Addendum No. 2
Solicitation 26-99313
2026 Citywide Patch and Sidewalk

SP-18 (2433) PILASTER CAP

RECORD DRAWING

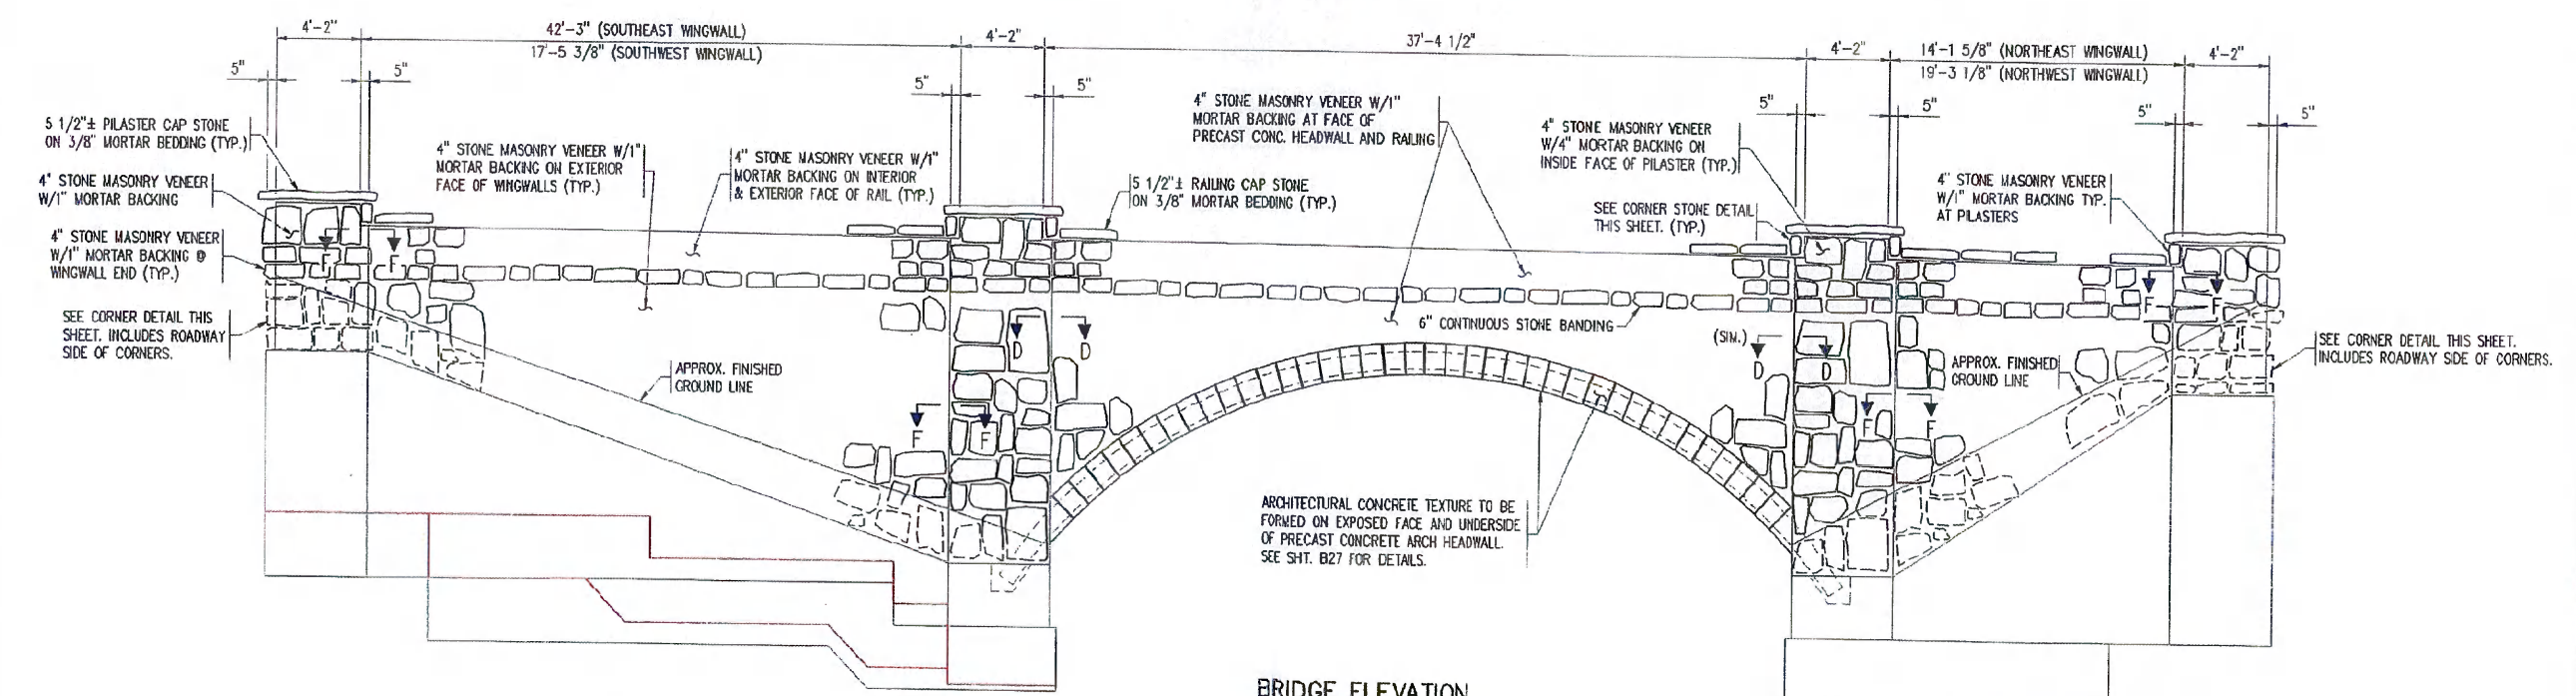
This work consists repairing and resetting 2 pilaster caps on Bridge 3 of Seven Bridges Road. The bridges over Amity Creek are numbered from the bottom of the hill. The record drawing for Bridge 69671 has been included in the plan, and includes details of how the stainless steel dowels and the pilaster caps shall be set on all of the pilasters and railings.

Drill and grout the dowel bars into the existing pilaster the epoxy resin adhesive in accordance dimensions and depth shown by the attached record drawing and detail. The pilaster may have dowels in place that can be used, and may not require new bars to be drilled. Verify condition of any in place dowels, ensure the setting bed is plumb, square, solid, secure and property prepared with engineer prior to setting the cap.
